Addendum No. 4

Solicitation Number: *FY23-ITBCON-35*

Title: *Franklin Water Treatment Plant Clearwell Improvements*

File: V:\FRANKLIN WTP CLEARWELL IMPROVEMENTS 01502\ELEC DWG\ALKALINITY\ED1 Saved by RLAWSON Save date: 6/6/2023 9:42 AM
PLOT DATE: 6/6/2023 10:35 AM BY: RLAWSON

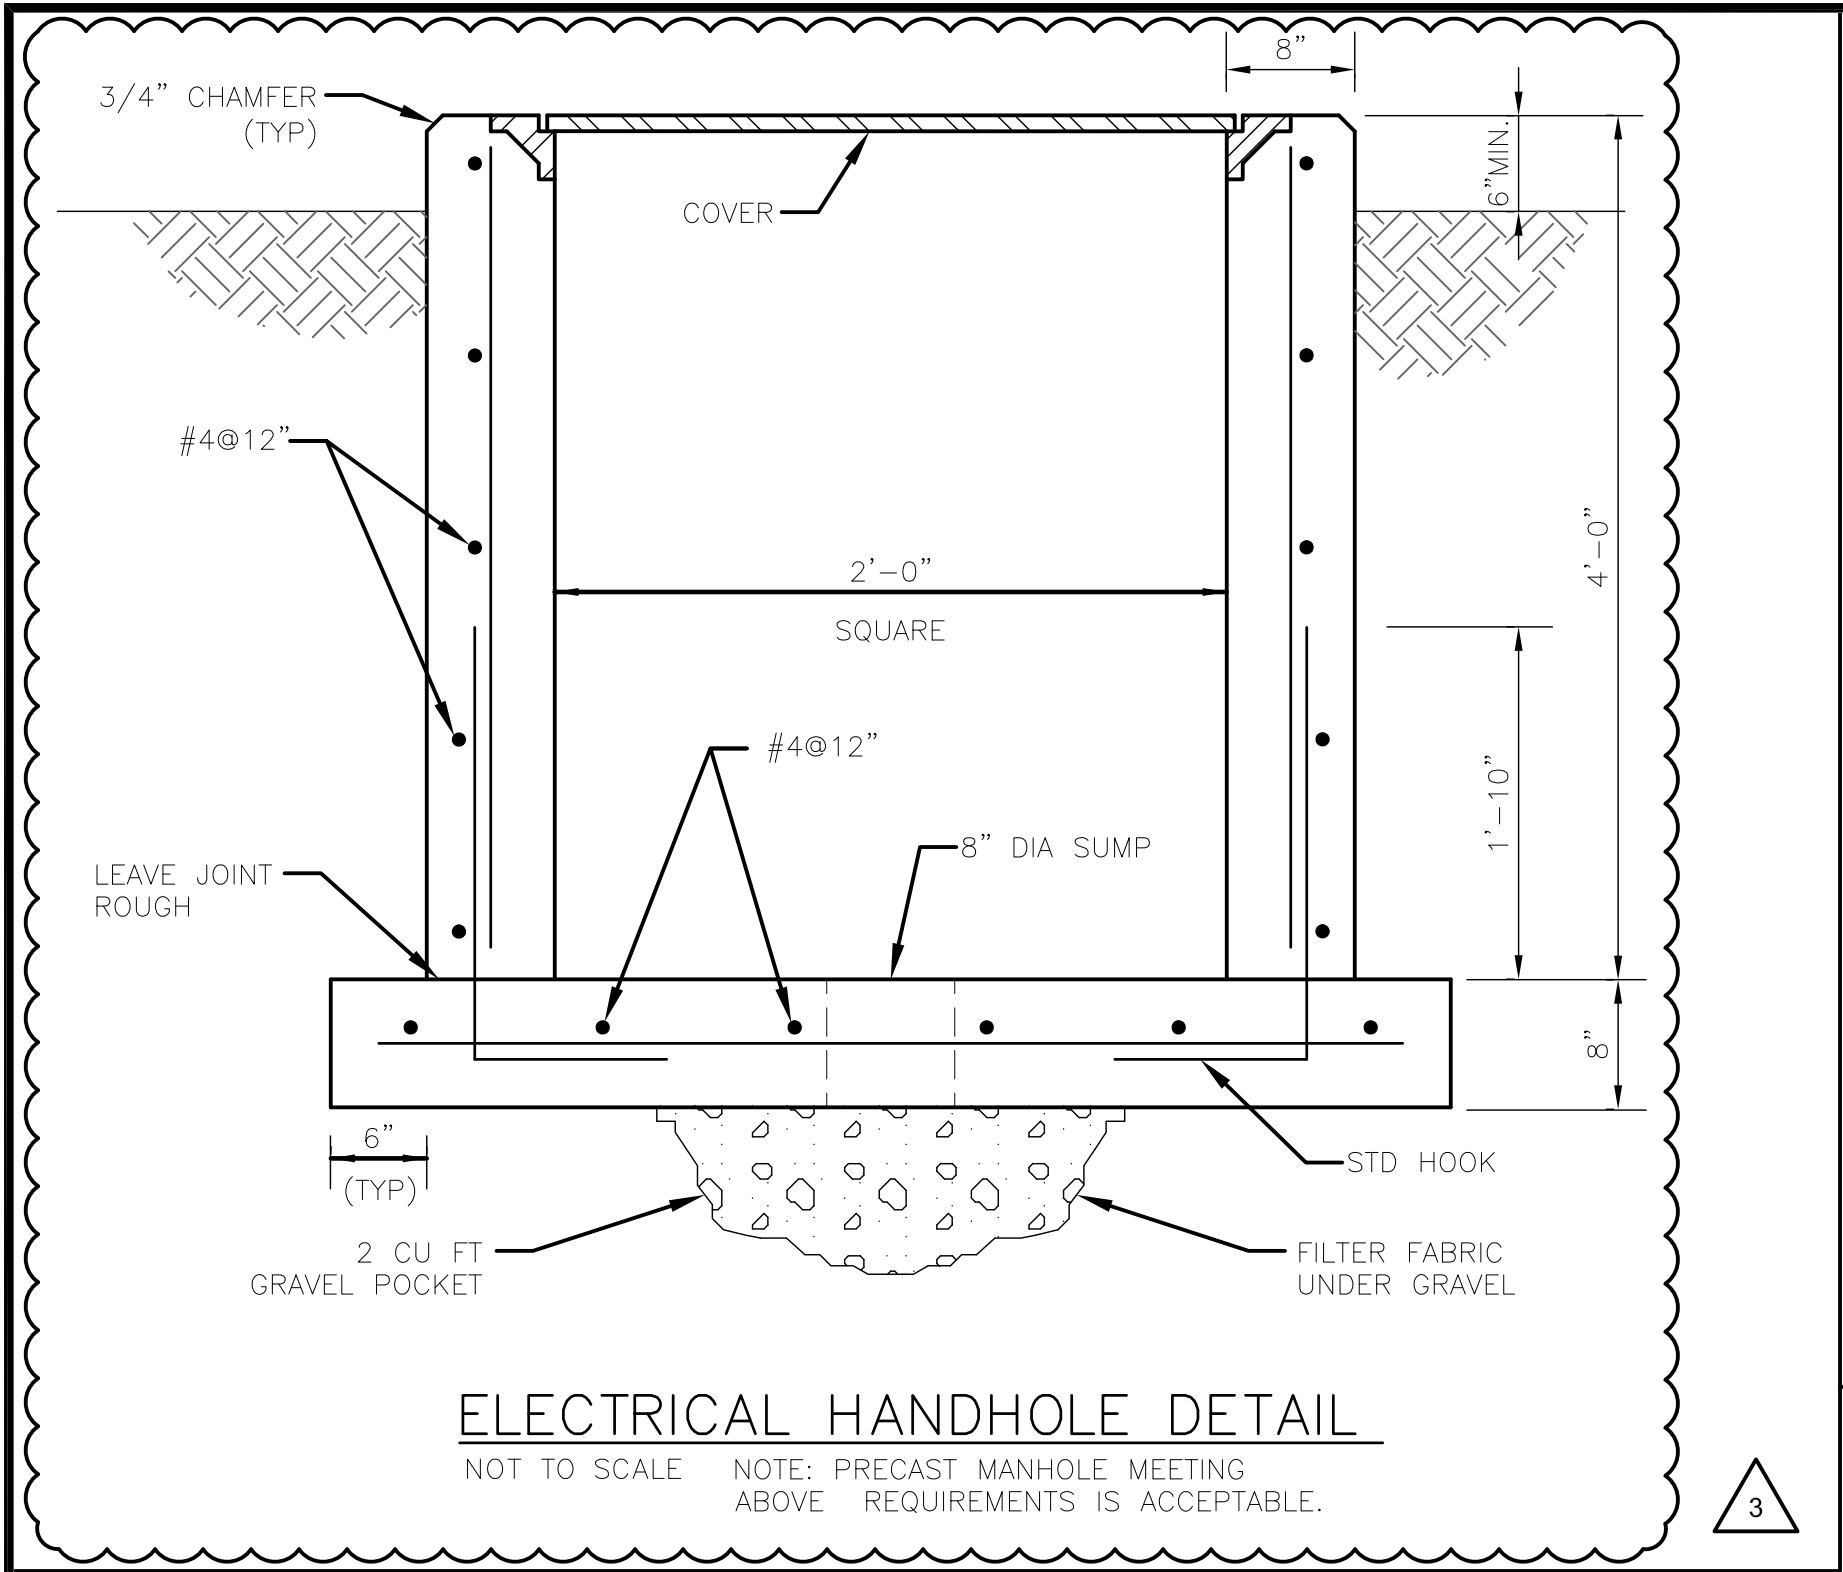
10	Contract Drawing ED2, Electrical Details	Revision No. 3	Replace Contract Drawing ED2 in its entirety with the attached revised Contract Drawing ED2. It has been revised to show names of equipment in the Electrical Rack Detail. An Electrical Handhole Detail has also been added.
